BEGBROKE PARISH COUNCIL

Planning Application 21/03522/OUT

Illustration set 1 – Hedge and tree damage at PR9 site

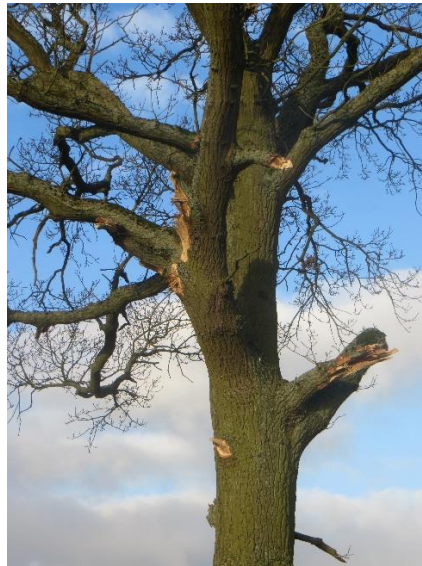
Dolton Lane after tree and hedge work.

- Cherwell Landscape said: The Parameter Green Infrastructure Plan must clarify that the hedgerows and trees within the productive areas are to remain and be protected. *The above images show what has happened in the past.*

Blocked and hidden drains

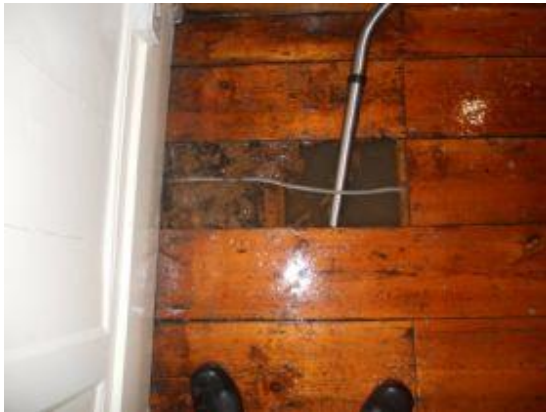
The series of images below shows water flow from east of Hall Farm Spring Hill down to St Michaels Lane, flooding the Old Rectory, high water by Orchard House, a flooded burial ground at the church and continuing to the A44. Whilst some are not on Merton Land, they are inserted to show the impact of rain and the build up of water across the area and not in isolation.
